Board of Zoning and Building Appeals
CITY HALL COUNCIL CHAMBERS
AGENDA OF FEBRUARY 27, 2025
7:00 PM

PPZ2025-0331: UH Urgent Care, 34548 Center Ridge Rd, PPN 07-00-016-101-054

PPZ2025-0333: North Ridgeville City Schools Transportation & Maintenance Center, 7001 Ranger Way, PPN 07-00-016-104-233

PPZ2025-0334: Javier Feliciano, 5884 Rosebelle Ave, PPN 07-00-020-108-019

UHUC-L-FL-60

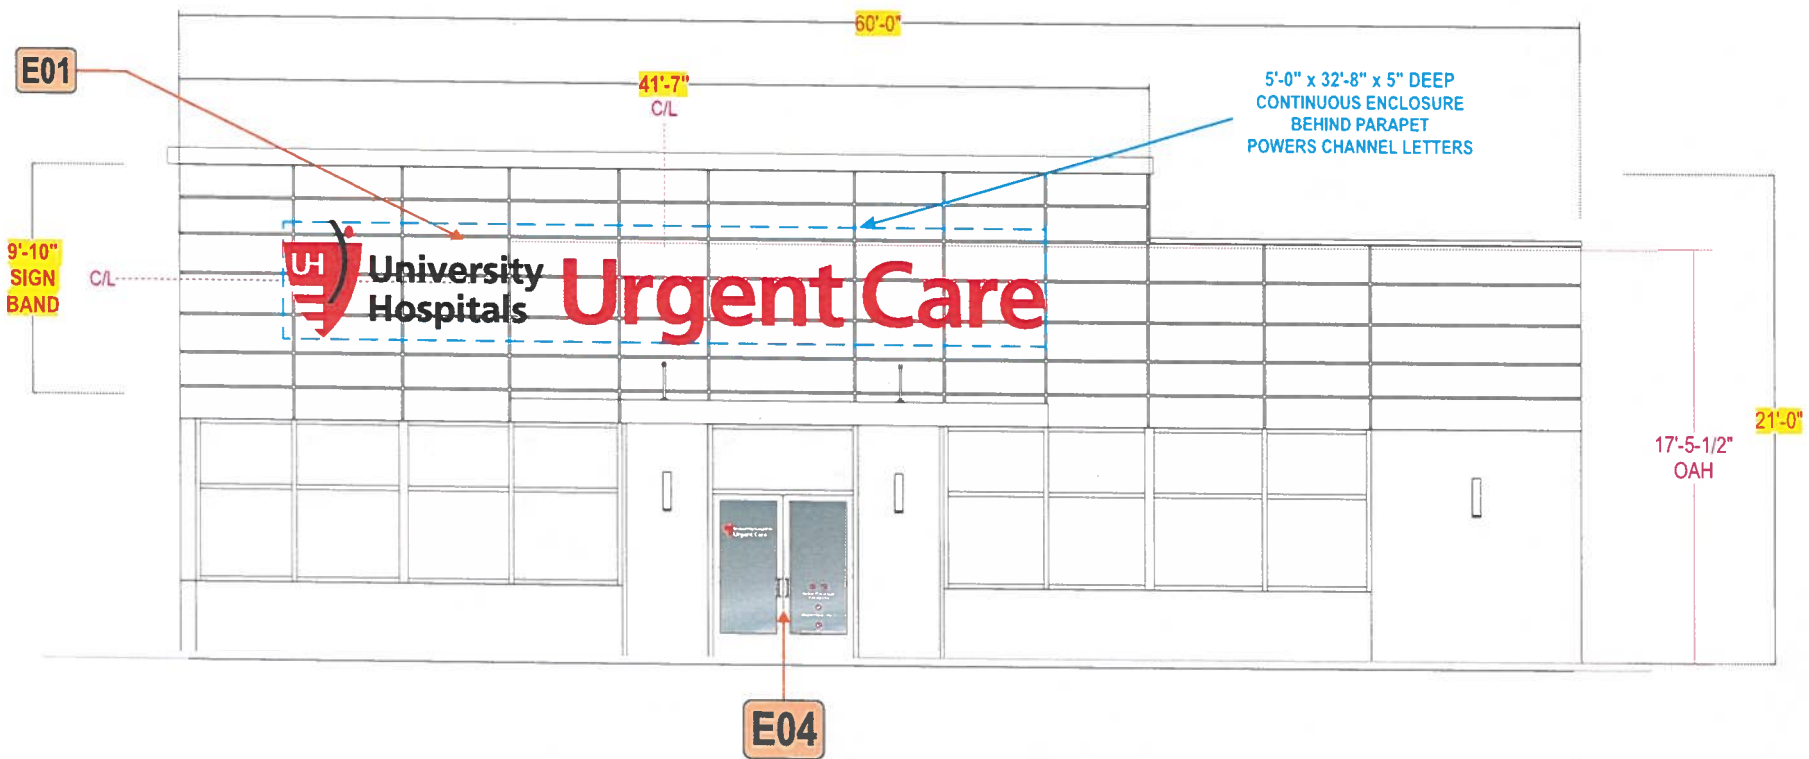
1. A 311.58 square foot variance for area of building signs. Applicant shows 431.58 square feet, code allows 120 square feet, Section 1286.11(a)(1)(A).
2. A variance for a second monument sign. Applicant shows two ground signs (existing Scooter's and proposed UH), code allows one, Section 1286.11(c)(1).

ALLOWED SIGN SF:	120
PROPOSED SIGN SF:	163.0

UHUC-S-FL-84

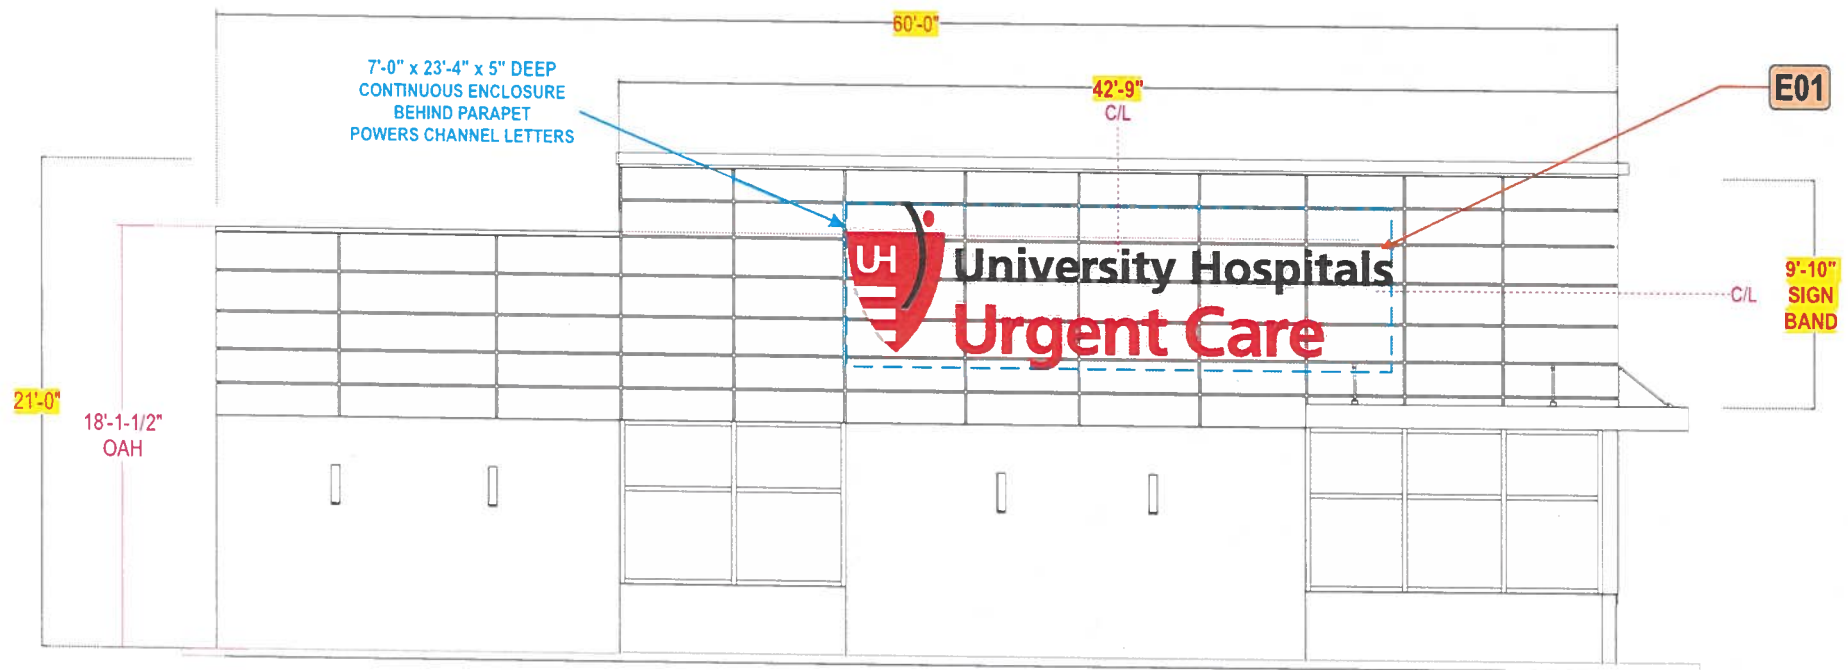
ALLOWED SIGN SF:	120
PROPOSED SIGN SF:	143.2

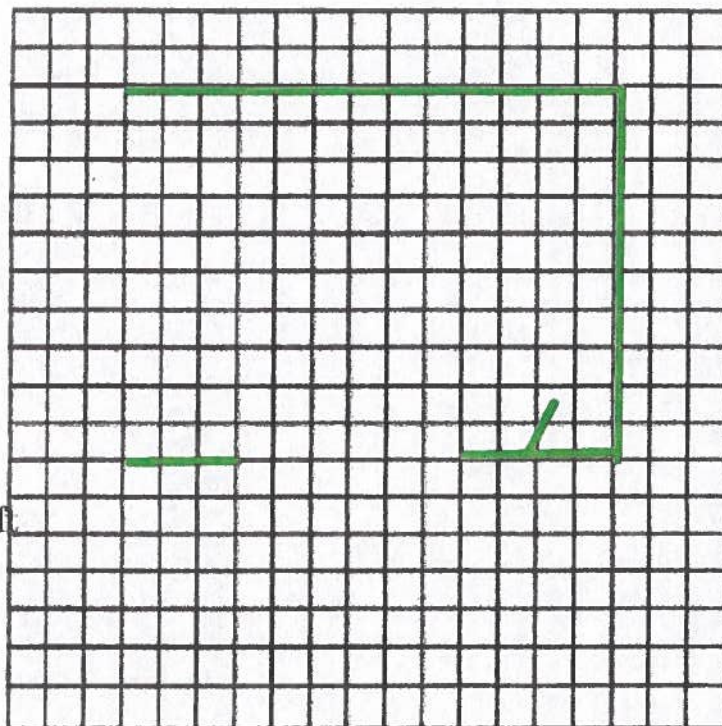
1. A 9-foot variance for a fence extending beyond the front building line on a corner lot. Applicant shows a 6-foot-high privacy fence extending 9 feet beyond the front building line, code does not permit, Section 1294.01(h)(2)(A).

With utilization of neighbors fence in place, This is for the larger layout with bza submission to come out towards the sidewalk some.

② LIGHT POLE DETAIL

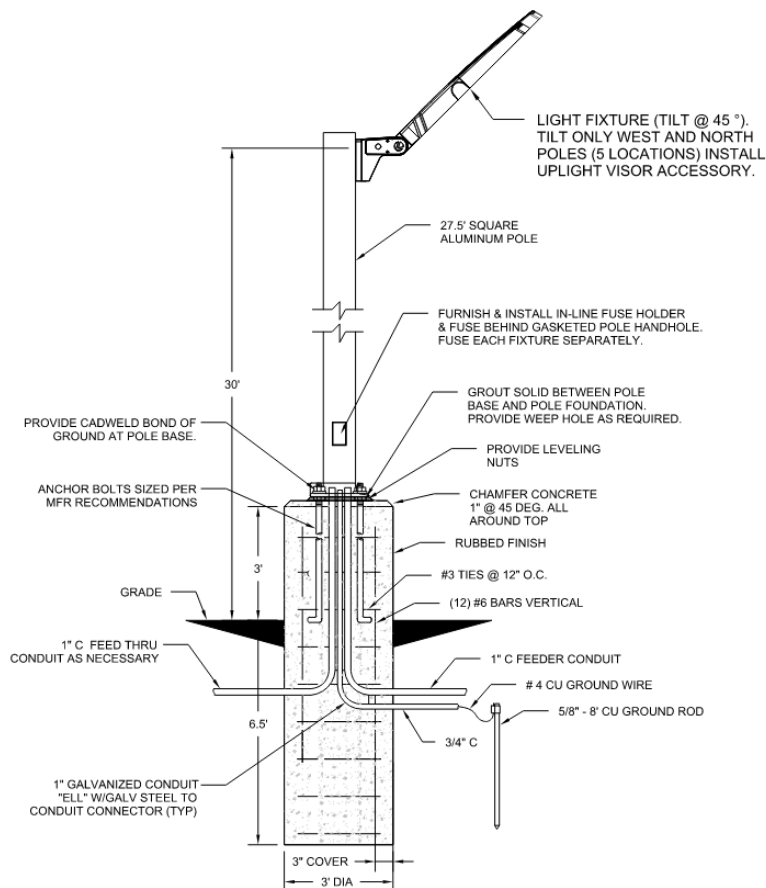
2. A 14-foot variance for luminaire height. Applicant shows fixture height of 30 feet, code allows 16 feet in residential districts, Section 1285(d).	(d) <u>Luminaire Height</u> . The height of any parking lot light fixture shall not exceed 30 feet above grade in industrial districts and 25 feet above grade in all other non-residential districts. When located within 50 feet of a residential zoning district, the height of a parking lot light fixture shall not exceed 16 feet above grade. The Planning Commission may require lower mounting heights if the adjoining grade is lower than developed grade.

The lighting plan deviates from Zoning Code requirements in three ways. First, building lights are semi-cut-off and five of the new parking lot fixtures will be angled, therefore not full-cut off as required. Second, the lights will be mounted at 30 feet, where code allows 16 feet in residential districts. Third, lighting levels exceed code requirement for open parking areas.

The lighting poles are proposed to be 30' tall to match the existing fixtures on the Academic Center site. Please see detail of proposed light poles below. The fixtures themselves are a very similar style as those on campus already, with some that will be installed on existing poles exactly matching the style.

SUMMARY OF ISSUE:
DRAWING TITLE:
PHOTOMETRIC
SITE PLAN

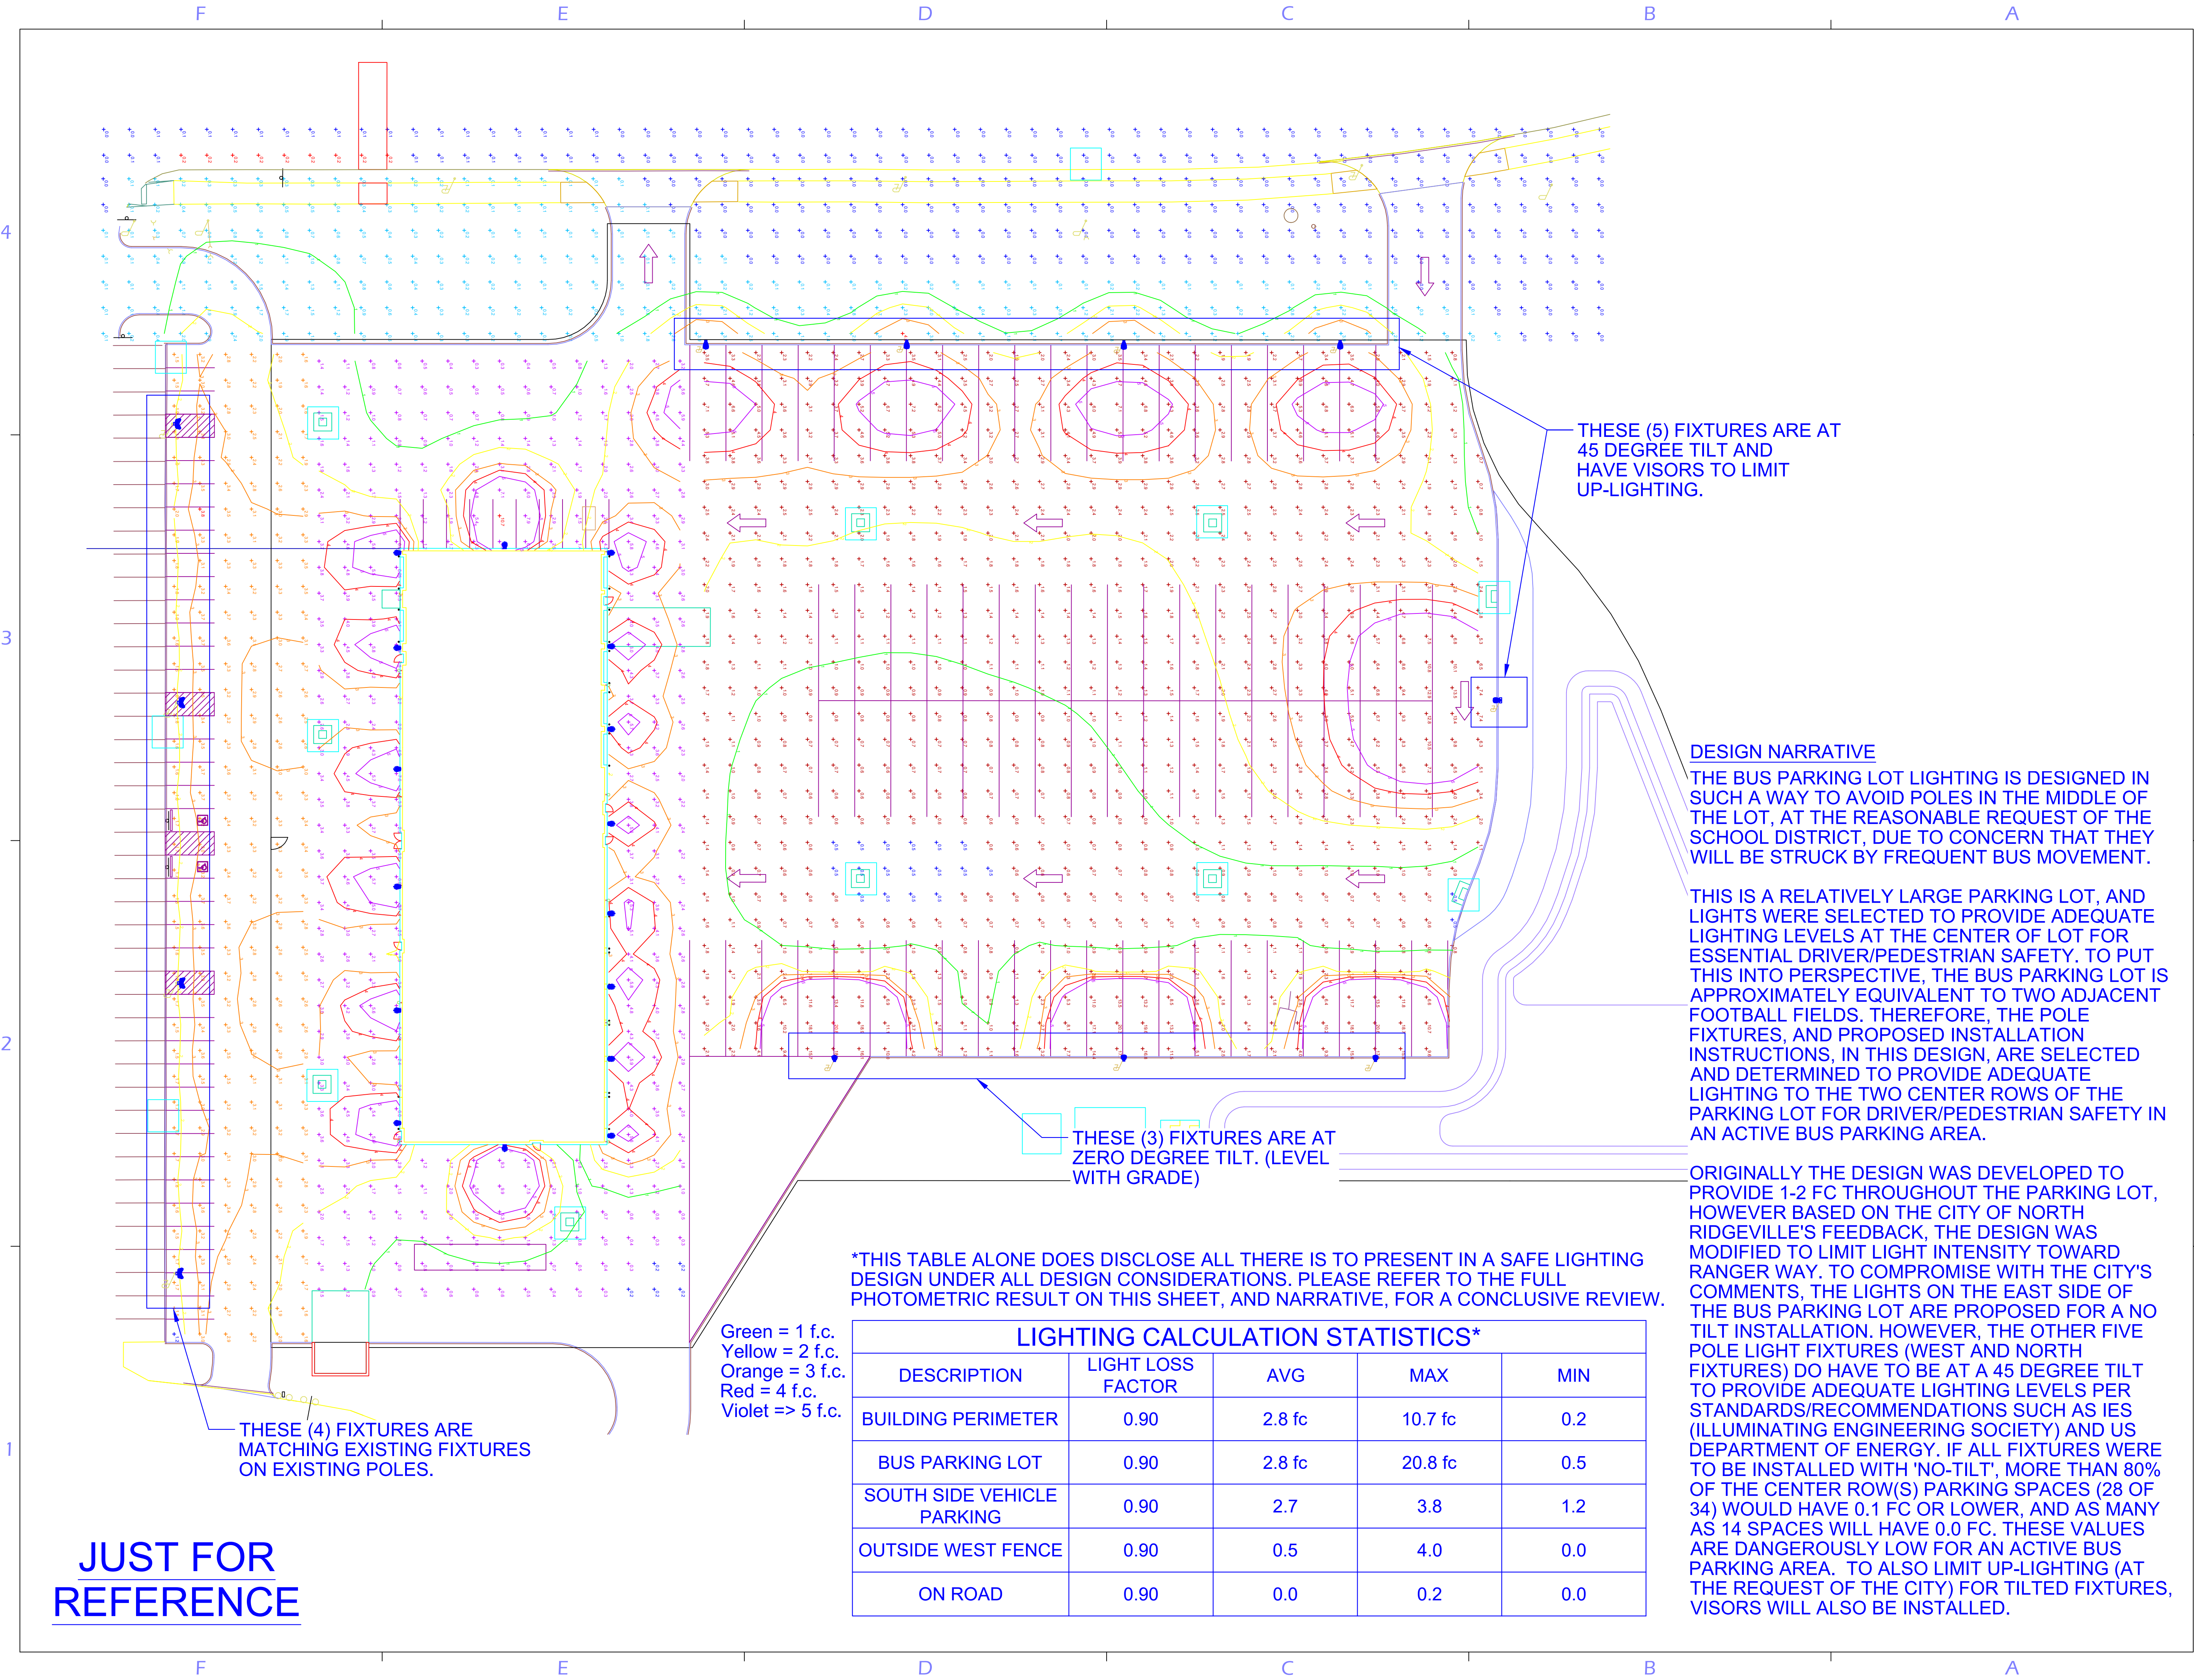
THIS IS A RELATIVELY LARGE PARKING LOT, AND LIGHTS WERE SELECTED TO PROVIDE ADEQUATE LIGHTING LEVELS AT THE CENTER OF LOT FOR ESSENTIAL DRIVER/PEDESTRIAN SAFETY. TO PUT THIS INTO PERSPECTIVE, THE BUS PARKING LOT IS APPROXIMATELY EQUIVALENT TO TWO ADJACENT FOOTBALL FIELDS. THEREFORE, THE POLE FIXTURES, AND PROPOSED INSTALLATION INSTRUCTIONS, IN THIS DESIGN, ARE SELECTED AND DETERMINED TO PROVIDE ADEQUATE LIGHTING TO THE TWO CENTER ROWS OF THE PARKING LOT FOR DRIVER/PEDESTRIAN SAFETY IN AN ACTIVE BUS PARKING AREA.

ORIGINALLY THE DESIGN WAS DEVELOPED TO PROVIDE 1-2 FC THROUGHOUT THE PARKING LOT, HOWEVER BASED ON THE CITY OF NORTH RIDGEVILLE'S FEEDBACK, THE DESIGN WAS MODIFIED TO LIMIT LIGHT INTENSITY TOWARD RANGER WAY. TO COMPROMISE WITH THE CITY'S COMMENTS, THE LIGHTS ON THE EAST SIDE OF THE BUS PARKING LOT ARE PROPOSED FOR A NO TILT INSTALLATION. HOWEVER, THE OTHER FIVE POLE LIGHT FIXTURES (WEST AND NORTH FIXTURES) DO HAVE TO BE AT A 45 DEGREE TILT TO PROVIDE ADEQUATE LIGHTING LEVELS PER STANDARDS/RECOMMENDATIONS SUCH AS IES (ILLUMINATING ENGINEERING SOCIETY) AND US DEPARTMENT OF ENERGY. IF ALL FIXTURES WERE TO BE INSTALLED WITH 'NO-TILT', MORE THAN 80% OF THE CENTER ROW(S) PARKING SPACES (28 OF 34) WOULD HAVE 0.1 FC OR LOWER, AND AS MANY AS 14 SPACES WILL HAVE 0.0 FC. THESE VALUES ARE DANGEROUSLY LOW FOR AN ACTIVE BUS PARKING AREA. TO ALSO LIMIT UP-LIGHTING (AT THE REQUEST OF THE CITY) FOR TILTED FIXTURES, VISORS WILL ALSO BE INSTALLED.
